EL CAR WASH JSP23-41

Consideration of El Car Wash for Preliminary Site Plan and Stormwater Management Plan approval. The subject property is 1.22 acres in size and is located on the north side of Grand River Avenue, east of Wixom Road. The subject property is zoned B-3 General Business. The applicant is proposing to demolish the former PNC bank building and construct a 3,700 square foot, drive-thru car wash.

Second Revised Preliminary Site Plan

Review Date: March 19, 2024
Review Type: Second Revised Preliminary Site Plan
Project Name: JSP23-41 El Car Wash
Plan Date: February 26, 2024
Prepared by: James Hill
Contact: E-mail: jhill@cityofnovi.org Phone: (248) 347-0547

South Elevation
3/16" = 1'-0"

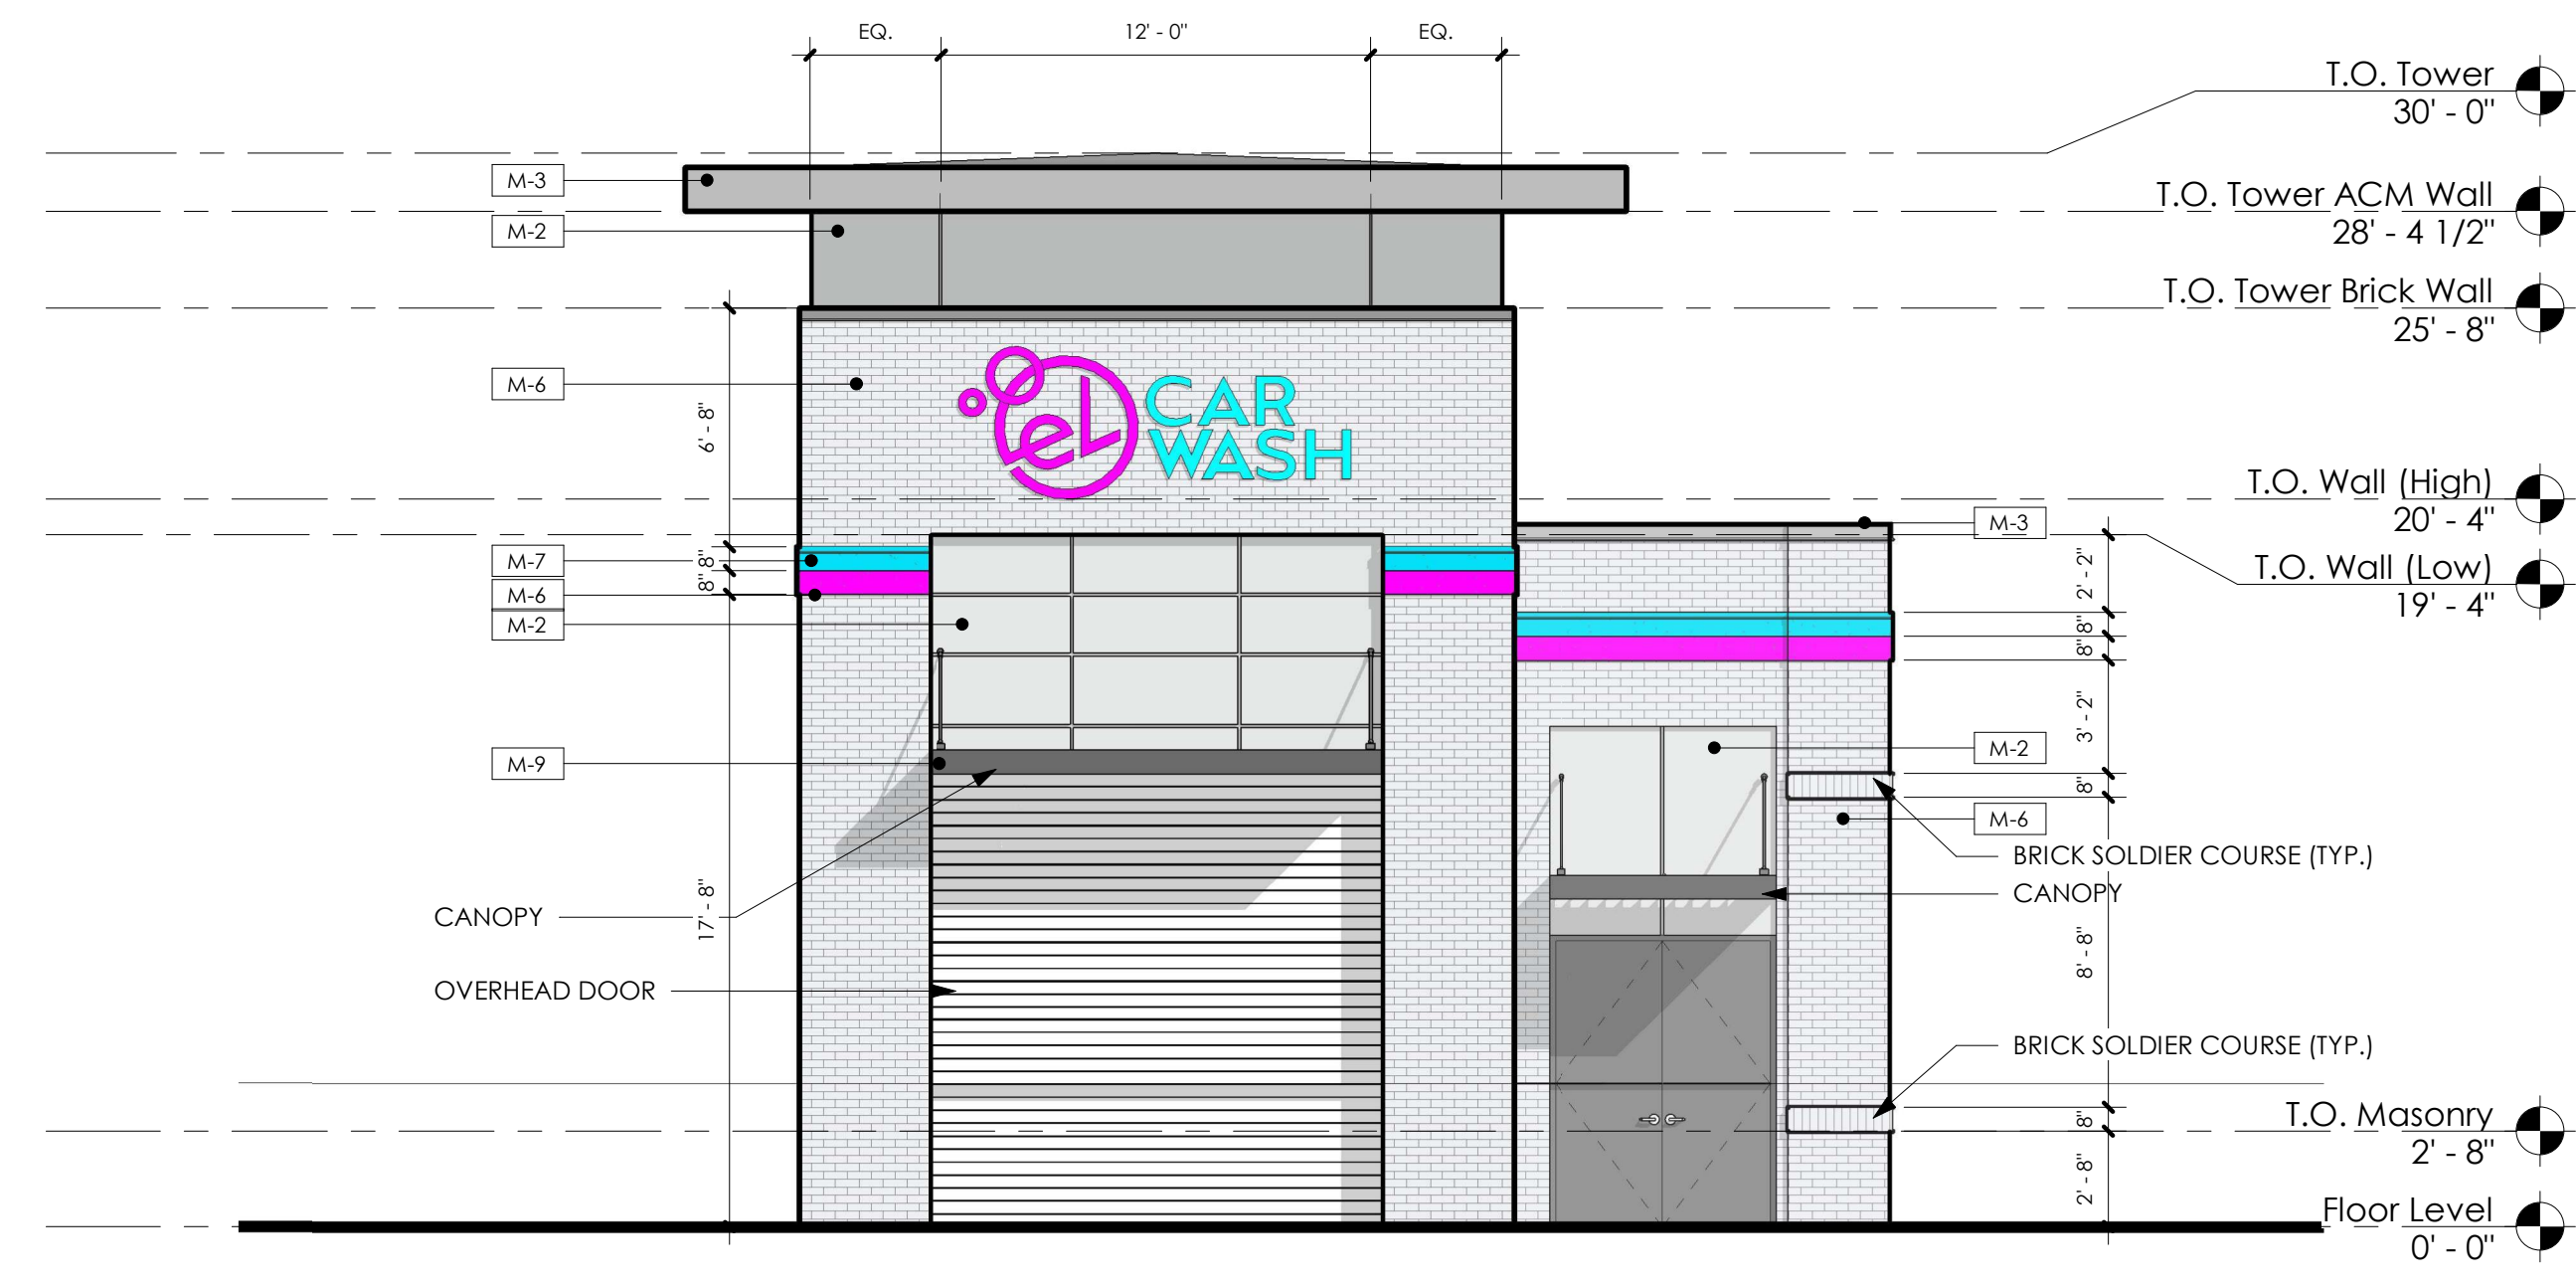
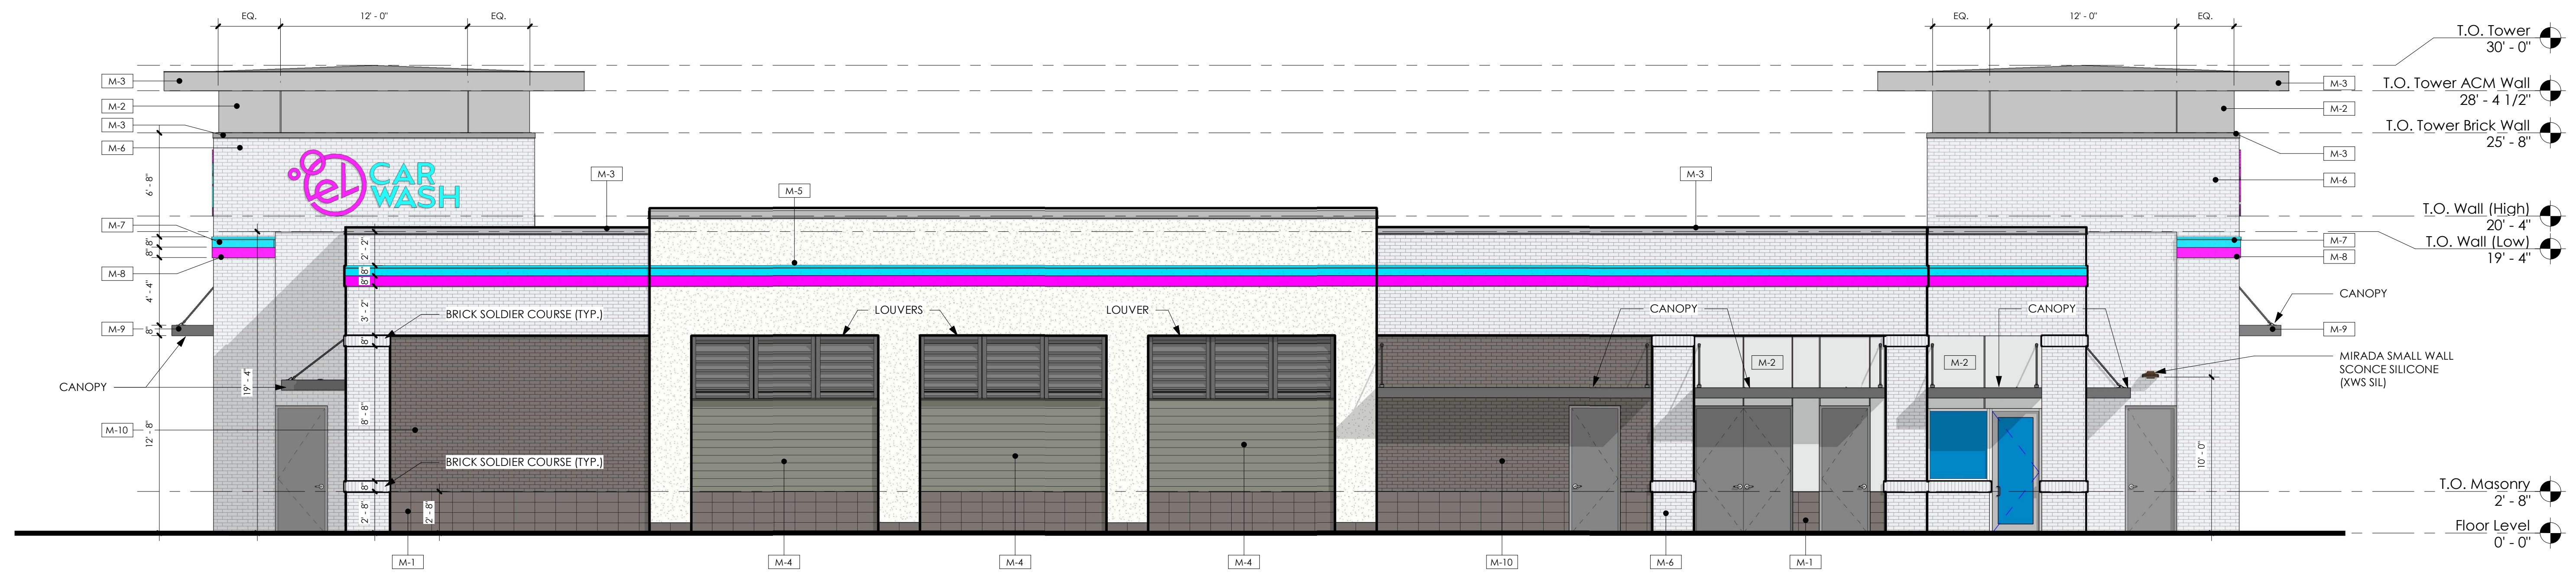
- a. The Zoning Board of Appeals granting a variance from Section 3.10.3 of the Zoning Ordinance for proposing an overhead door facing a major thoroughfare (Grand River Avenue) *because there is existing and proposed landscaping to screen the overhead door from Grand River Avenue;*
- b. The findings of compliance with Ordinance standards in the staff and consultant review letters and the conditions and the items listed in those letters being addressed on the Final Site Plan; and
- c. *(additional conditions here if any)*

STONEFIELD engineering & design
SCALE: 1" = 20' PROJECT ID: DET-230271
TITLE: LANDSCAPING PLAN
DRAWING: C-8

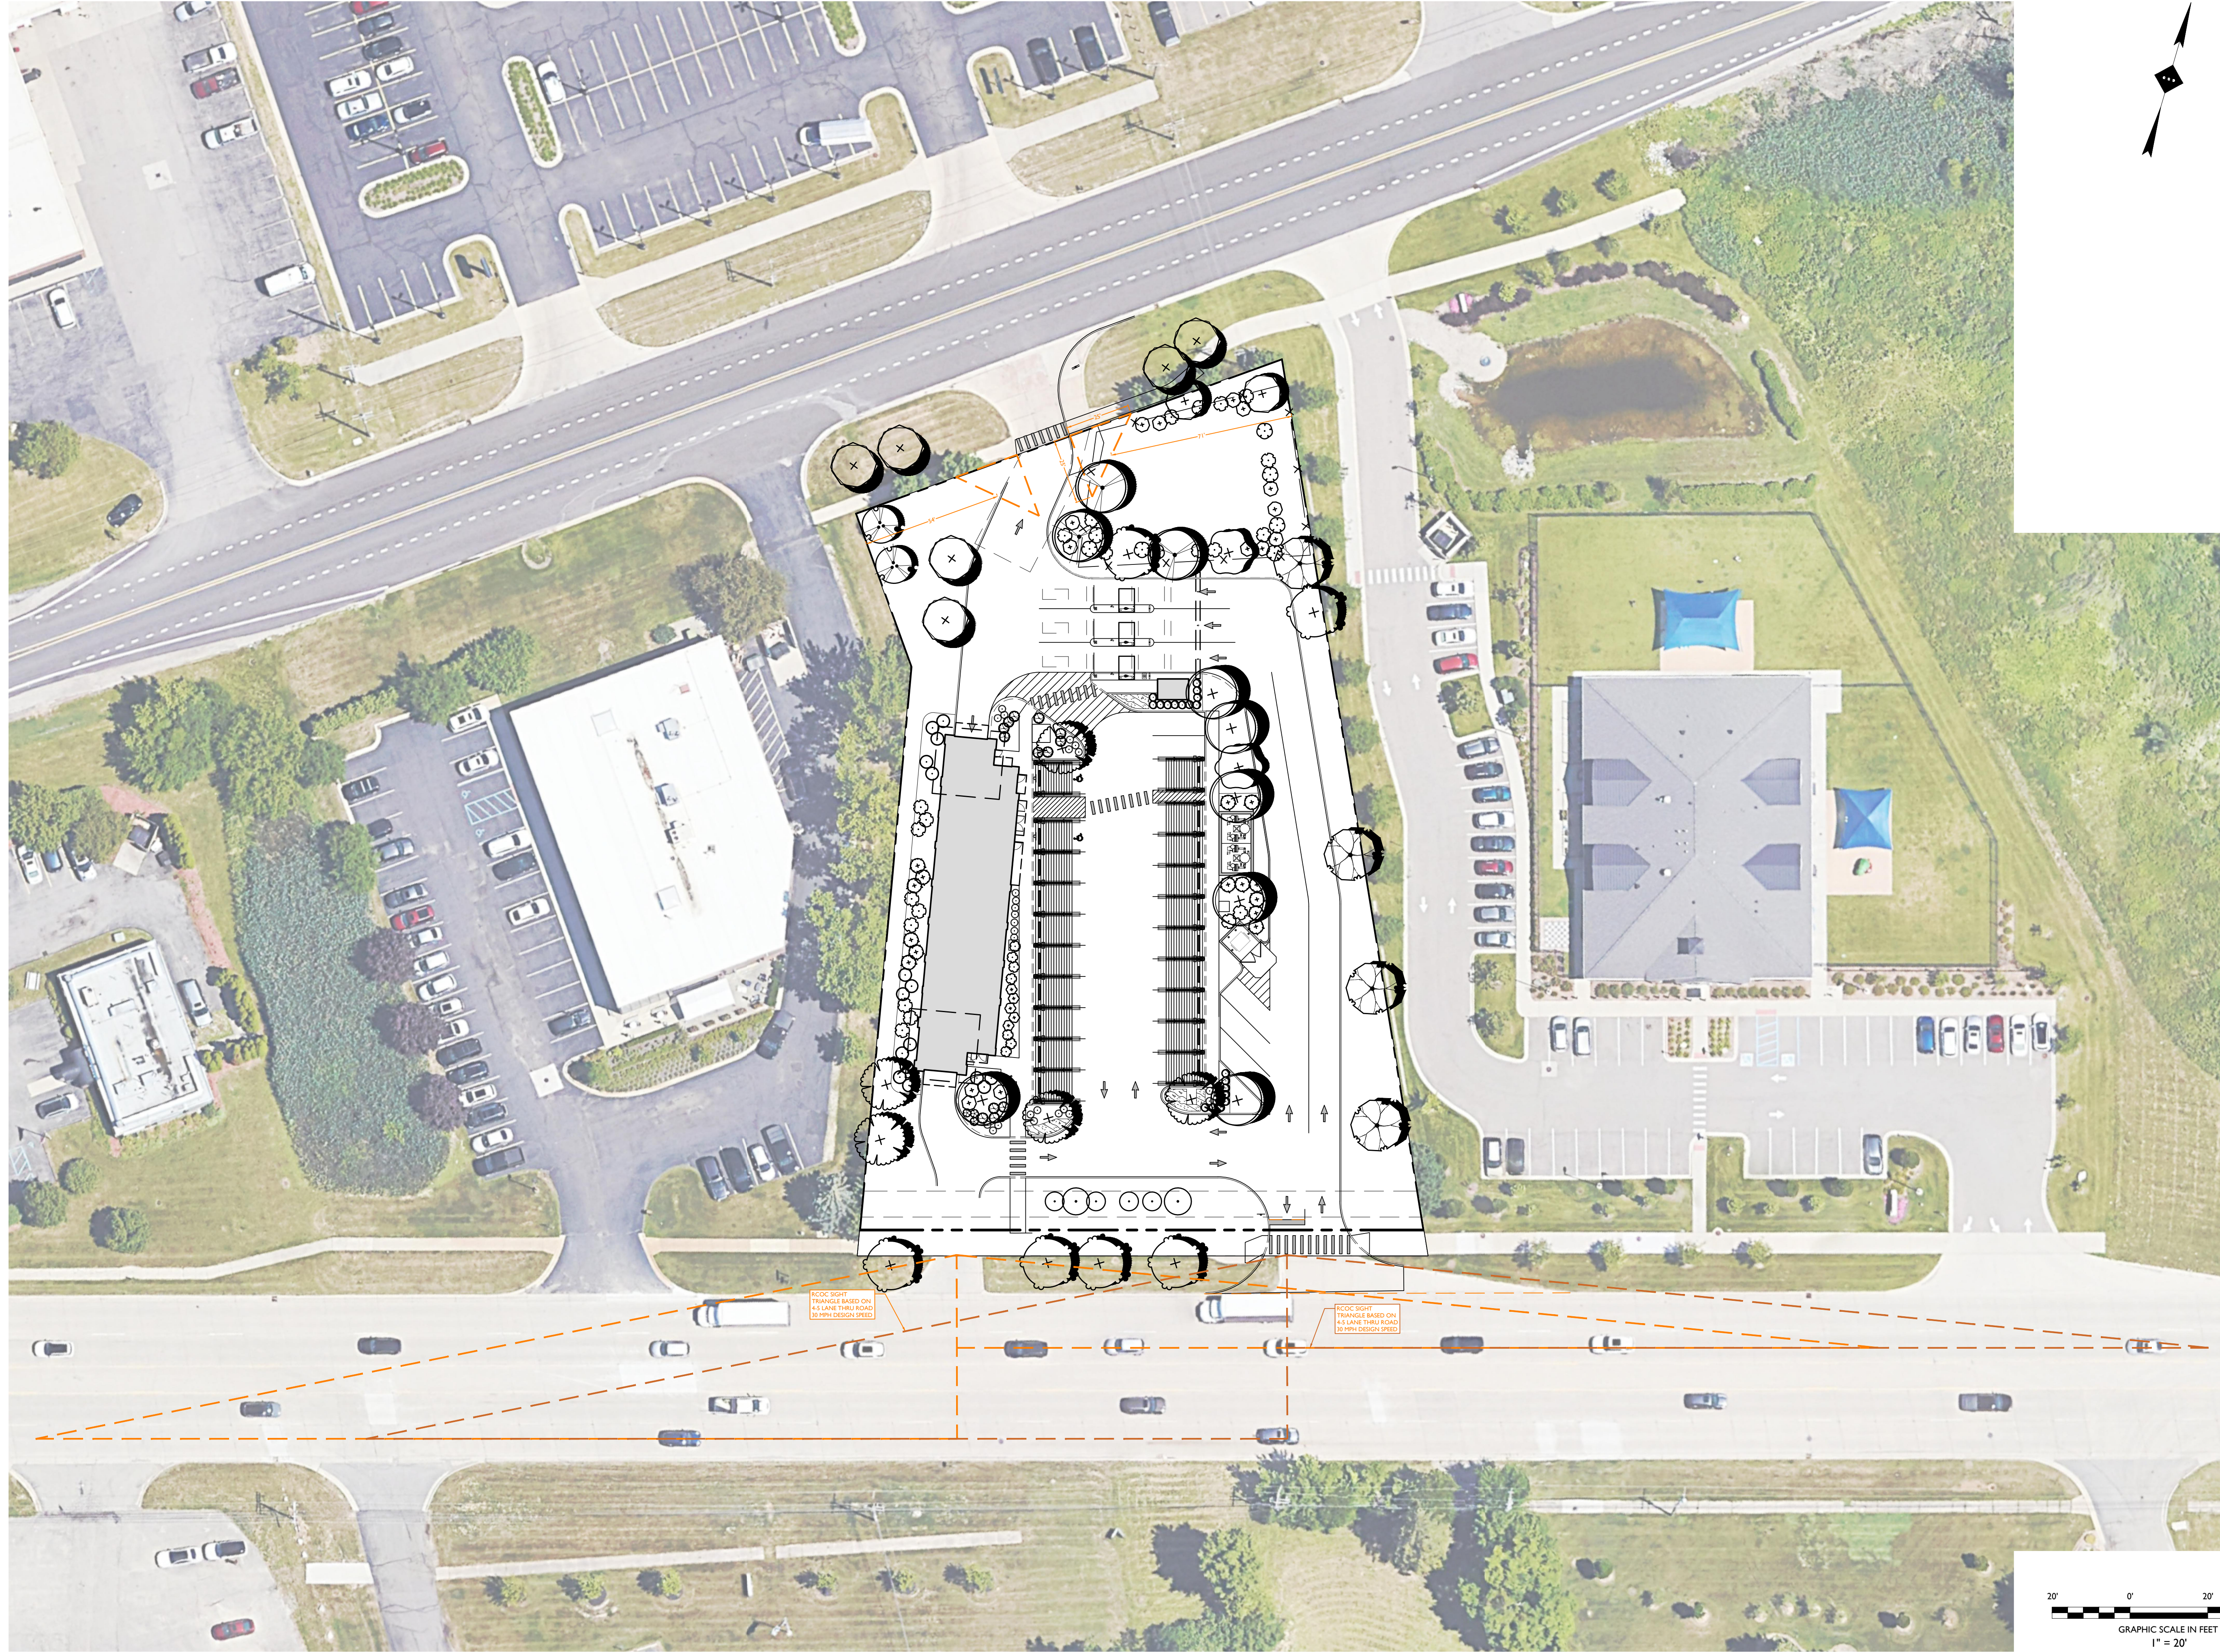
1. The calculations are correct for the interior trees, but one of the required trees is shown outside of the vacuum area, versus in an interior island or corner. **A landscape waiver is required for this.** *If the parking lot perimeter tree situation is corrected, this waiver can be supported by staff.*
2. 6 parking lot perimeter trees are required but only 5 are provided. **Please see the discussion on the Landscape Chart for what should be done regarding the perimeter trees.**
3. 27 accessway perimeter trees are required and 27 are provided.

Item	Required	Proposed	Meets Code	Comments
				<p>any deficiency in trees provided. It would be supported by staff if three trees are provided.</p>
<p>Parking Lot Perimeter Trees (Sec 5.5.3.C.iv)</p>	<p>1 Canopy tree per 35 lf 201/35 = 6 trees (The perimeter within 20 feet of the building may be deducted from the calculation).</p>	<ul style="list-style-type: none"> • 5 trees • The four trees at the northeast corner are too crowded. 	<p>No</p>	<ol style="list-style-type: none"> 1. Please remove at least one of the parking spaces east of the vacuum area, convert it to greenspace and add 1 tree there. 2. The interior tree (NYS) does not need to be there. Remove it and spread the remaining 3 trees out. 3. A landscape waiver would be required for any deficiency in trees provided. It would not be supported by staff.
<p>Accessway perimeter</p>	<p>One deciduous canopy tree per 35lf on either side of accessways that don't have parking on both sides 939/35 = 27 trees</p>	<ul style="list-style-type: none"> • 7 existing canopy trees • 20 proposed trees 	<p>Yes</p>	<ol style="list-style-type: none"> 1. Existing canopy trees within 15 feet of the paving can be counted toward the requirement. 2. The parking lot perimeter trees may double-count as accessway perimeter trees in the long island between the vacuum area and the entry drive. 3. Please move one of the trees along the south side of the basin to the gap near the end of the detention system and spread the detention basin trees out. 4. Please move the southern CCA east to be closer to the drive so it will shade it more.

I have attached as Exhibit 1 a detailed response letter to all of the City review comments. Please note, that the Applicant is seeking only one Planning Commission Landscape Waiver for a deficiency of one interior parking lot tree. The reviews noted a deficiency for parking lot perimeter trees which will be corrected by the Applicant and the Landscape review indicated that if the parking lot perimeter tree deficiency was corrected the waiver for the single tree interior parking lot deficiency would be supported by staff. The Applicant will correct the parking lot perimeter tree deficiency.
